ARCHITECT'S SUPPLEMENTAL INSTRUCTIONS

Table with project details: PROJECT: Landmark on Cypress, OWNER: OPG Cypress Partners, LLC, CONTRACTOR: MCP Group, Report No. Four (4), Date June 19, 2026, Architect's Proj No. 25-3483, Contract For: General Construction Mechanical, Electrical

**LANDMARK ON CYPRESS**  
HISTORIC REHABILITATION - APARTMENTS  
ABILENE, TEXAS

**SECOND FLOOR REFLECTED CEILING PLAN**

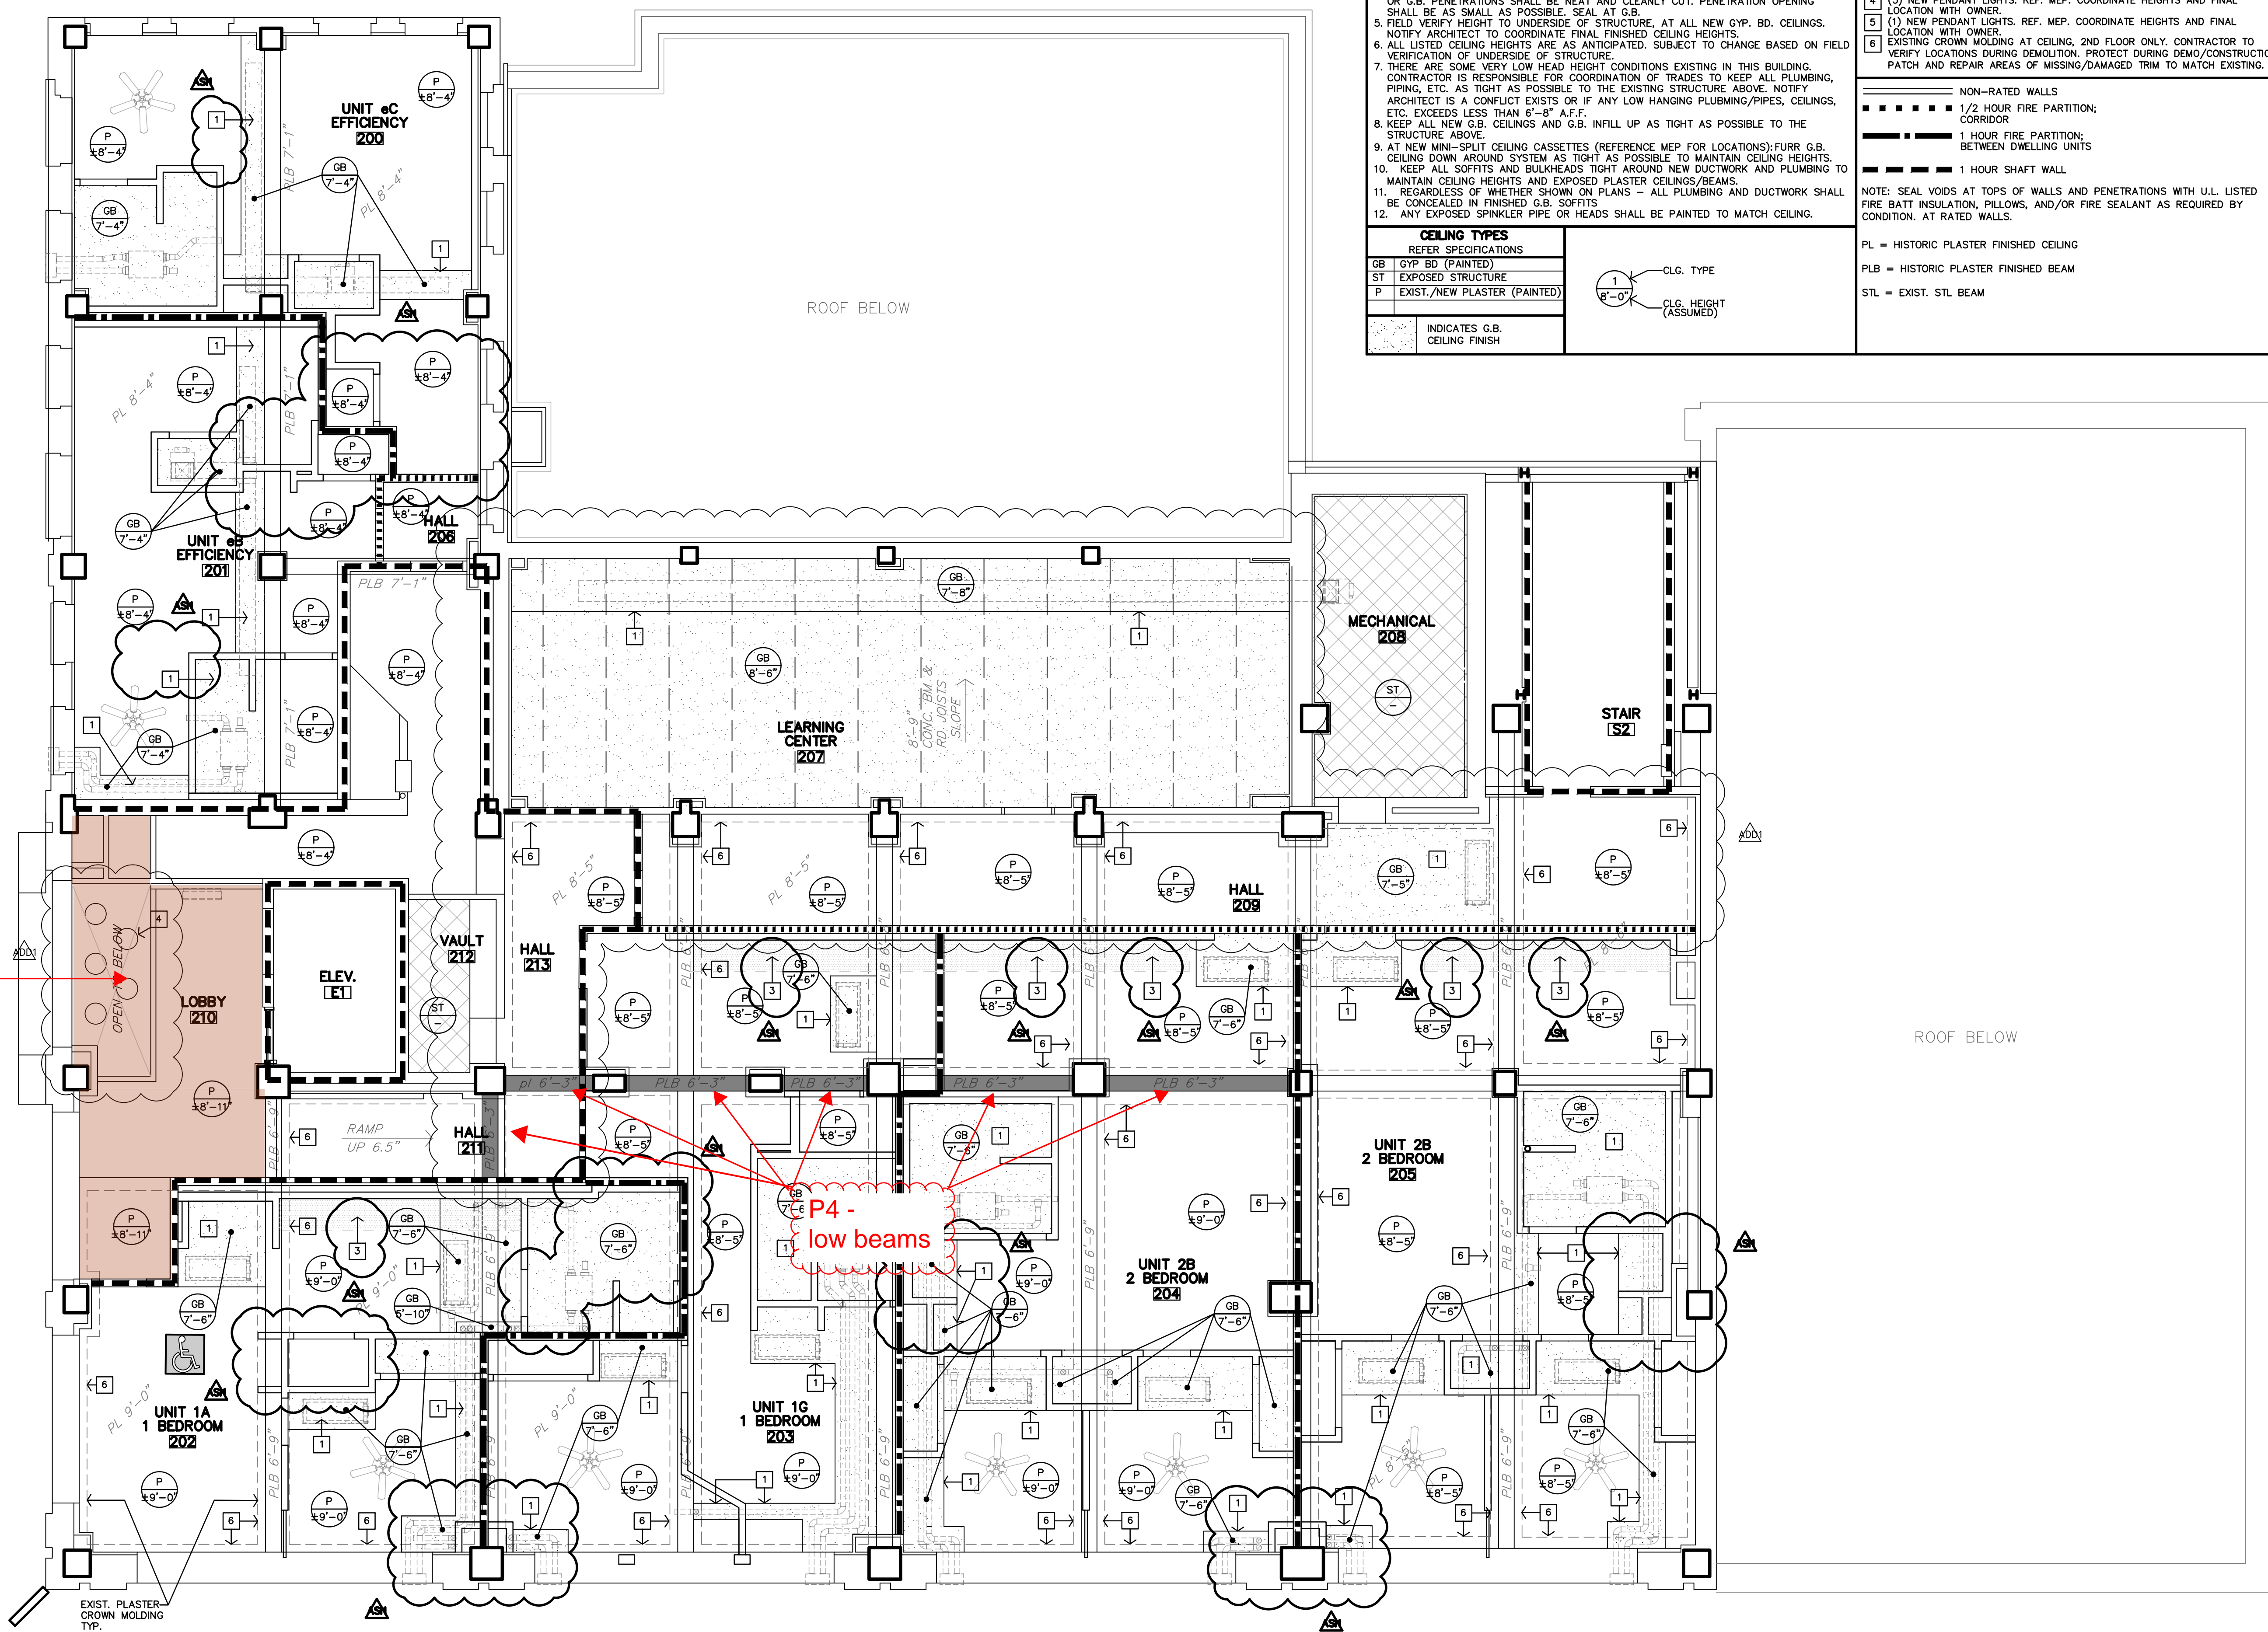
- 1x8 Trim Boards and 1x8 Base board on south wall in (Lobby 107)
Ceiling in Lobby #210 (See attached ceiling plan for location)

- All Apartment Entry Doors & Entry Door trim molding/surround.
G.B. Infill at existing elevator door opening (Lobby 107)
Door 103 into Lobby 107
Doors 122 & 127 into Community Room 117
Door 209 into Learning Center 207
Low Beams located in Hall 211, Hall 213, Unit 203 & Unit 204 (see attached ceiling plan for locations)
All handrails, guardrails and components

- 1. Sheet A7.2 - 2nd Floor Ceiling Plan with accent ceiling color locations
